## New Hydro Tanks

**Subject:** A new hydraulic tank has been developed. An internal baffle and a fill/oil level plug has been added to ensure proper fluid level and to prevent excessive internal fluid movement.

**Affected:** Sentar Sport and Stander RH beginning with S/N 48968, Small Frame Stander, Velke Hydro PG beginning with S/N 48979, Stander ZK beginning with S/N 48983 and Sentar3's beginning with S/N 49062. All units built after the serial range above have the new hydro tank installed.

Oil level and fill instructions.

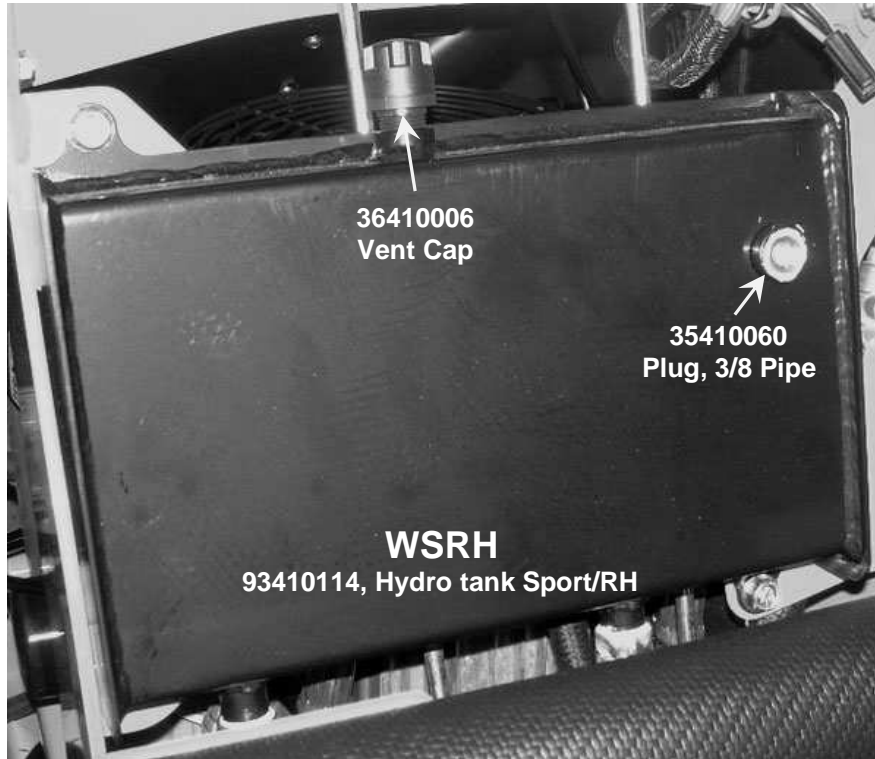
**Situation:** A new vent cap was installed to the current hydro tanks. In certain mowing conditions (hills, ditches), oil is leaking from the hydro tank vent cap. The new hydro tank can withstand a 42 degree slope without leaking. The fill/oil level port will allow for consistent oil levels.

- Park mower on level surface
- Remove oil level/fill plug.
- If oil flows out, reinstall plug once oil has stopped flowing.
- No oil flows, add approved oil until oil reaches the bottom fill plug threads.
- WSRH – Fluid can be added at either the vent cap or at the oil level/fill port.
- WSES – The vent is inaccessible to fill. Fill tank through oil level/fill port.
- SM. WS - The vent is inaccessible to fill. Fill tank through oil level/fill port.
- VK PG - Fluid can be added at either the vent cap or at the oil level/fill port.
- WSZK – Lift pad to access plug. The vent cap is accessible, however filling through the oil level/fill plug will be easiest.
- WSE3 – The dash will need to be removed to access the vent cap. Check and fill can be accomplished at the oil level/fill plug.
